Florida Power and Light Company
Advanced Systems and Technology

By our letter dated September 22, 1978, we transmitted to you
Amendment Nos. 38 and 31 to Facility License Nos. DPR-31 and DPR-41
for Turkey Point Unit Nos. 3 and 4.

Amendment No. 38
License No. DPR-31

Amendment No. 31
License No. DPR-41

REACTOR CORE THERMAL AND HYDRAULIC SAFETY LIMITS, THREE LOOP OPERATION

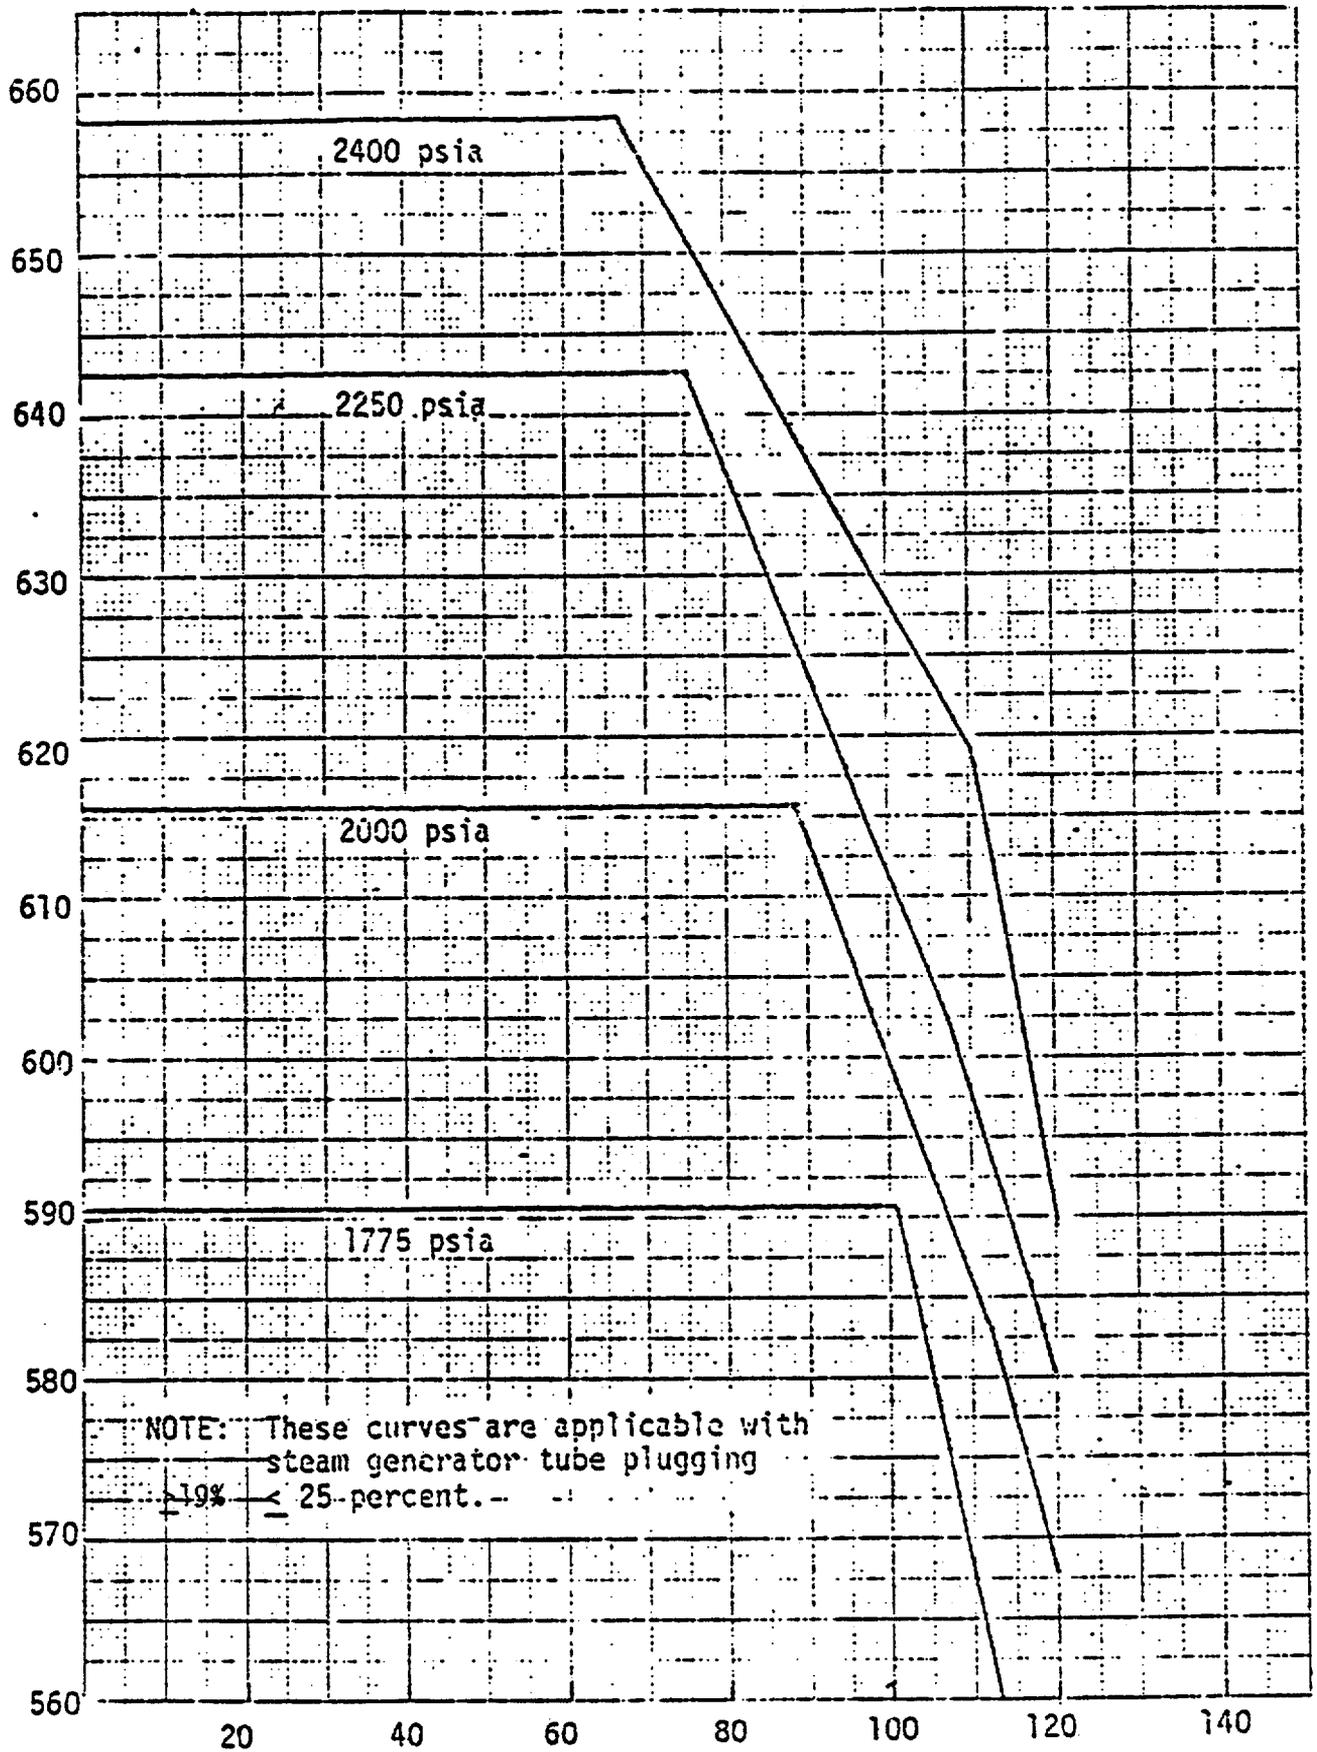
Figure 2.1-1b, "Reactor Core Thermal and Hydraulic Safety Limits, 3 Loop Operation" has been added to the Technical Specifications for operation with between 19 and 25 percent of the steam generator tubes plugged. These limits were generated by Westinghouse and are consistent with the limits for lower levels of plugging.

NOTE: These curves are applicable with steam generator tube plugging 19% to 25-percent.

FIGURE 3.2-3

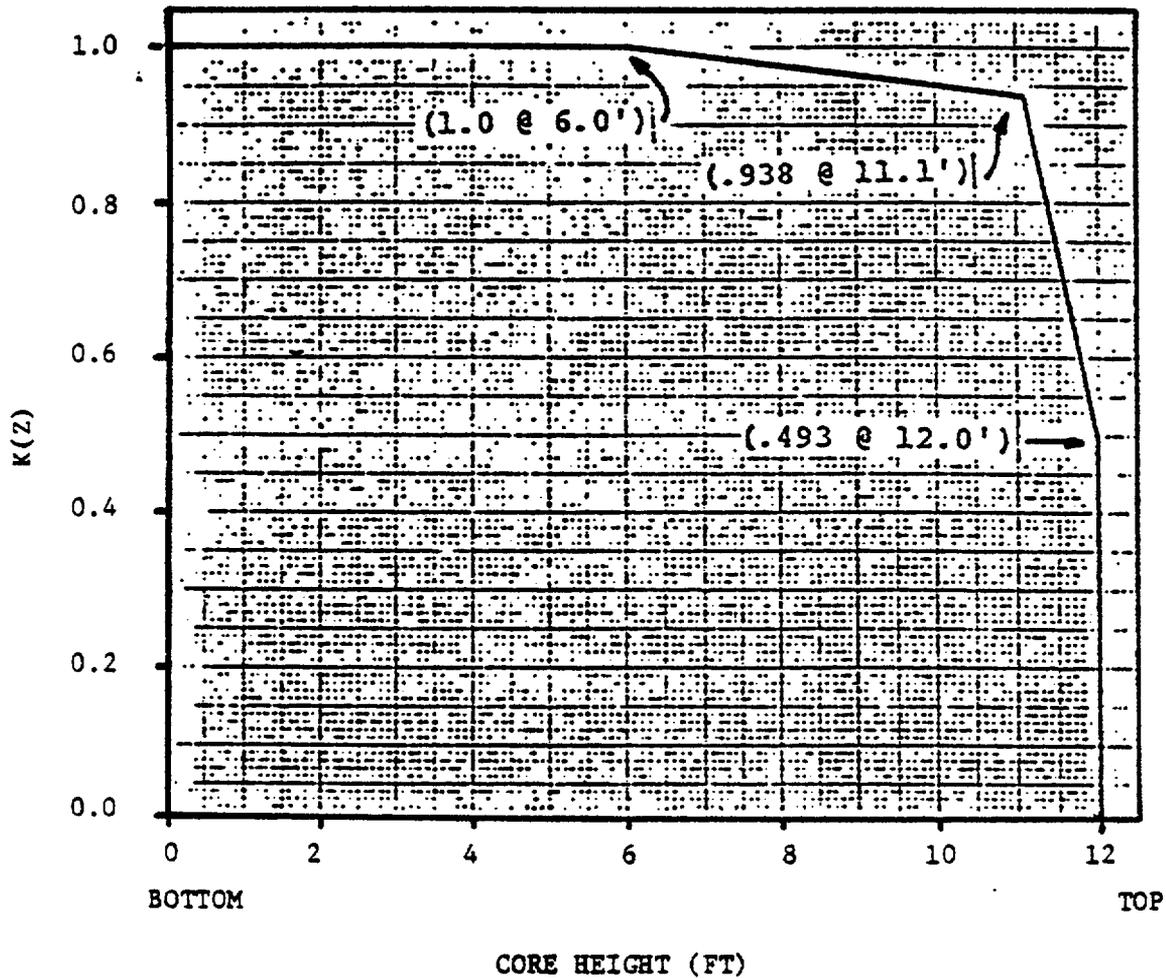
The normalized axial F_0 shaping factor (Figure 3.2-3) in the Technical Specifications has been changed consistent with the assumptions used as input for the LOCA analysis.

HOT CHANNEL FACTOR-NORMALIZED
OPERATING ENVELOPE (FOR STEAM
GENERATOR TUBE PLUGGING $\leq 25\%$ and $F_q = 2.03$)
